Docket Item # 6  
BAR CASE #2009-0188

BAR Meeting  
September 16, 2009

**ISSUE:** Alterations  
**APPLICANT:** Charles R. and Jane S. Weber  
**LOCATION:** 407 S. Saint Asaph Street  
**ZONE:** RM/Residential

Figure 2. Proposed six-over-nine replacement window

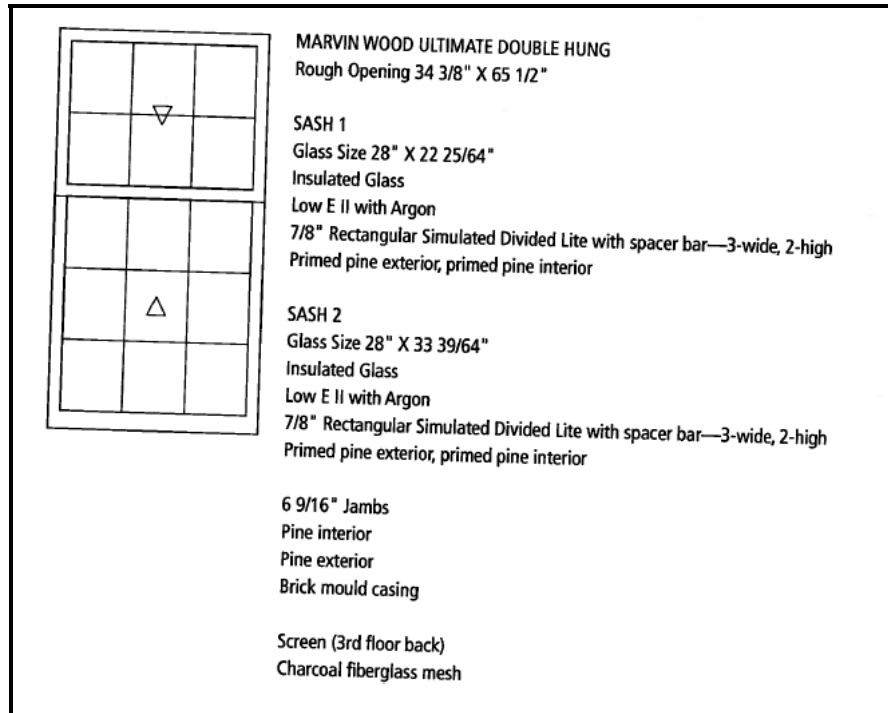
The applicant is requesting approval of a Certificate of Appropriateness for replacement windows at 407 South Saint Asaph Street. The applicant is proposing the replacement of thirteen windows on the front, rear, and side elevation of the home. The existing windows are single-glazed, double-hung, six-over-nine (first and second floor windows), six-over-six (third floor windows) and one, six pane round, wood windows with 7/8" muntins. The applicant is requesting approval to replace the existing windows and exterior storms with Marvin Ultimate Double Hung double-glazed windows with 7/8" muntins. The proposed windows will be simulated divided light with an interior spacer and a light pattern that is identical to the windows they are replacing. The windows will be painted to match the existing paint color.

**IV. STAFF RECOMMENDATION:** Staff recommends approval of the application as submitted.

Figure 5. Section detail with 7/8 inch muntins

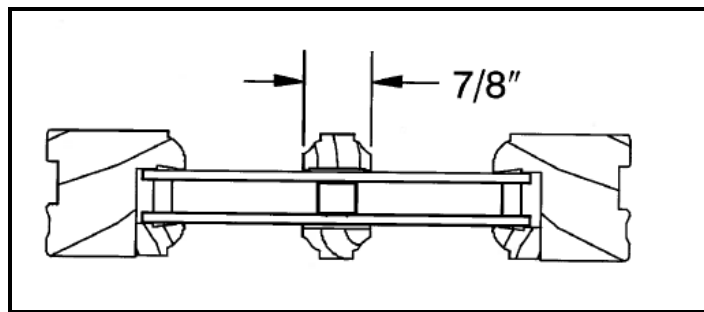
The *Design Guidelines* recommend that: "...replacement windows should be appropriate to the historic period of the architectural style of the building". The *Guidelines* state that single-glazed, true divided light windows with interior storm sash are the preferred replacement window type. The *Guidelines* continue by saying other acceptable window types are "double-glazed true divided light wood windows..." In this particular case, given the age of the townhouse and the fact that the existing light patterns, muntin profile, and muntin size will be retained, Staff does not object to the installation of double-insulated windows, with simulated divided lights, and interior spacer bars. These windows are comparable to the ones recently approved by the Board for replacement windows at 330 N. Royal Street and 605 Queen Street.
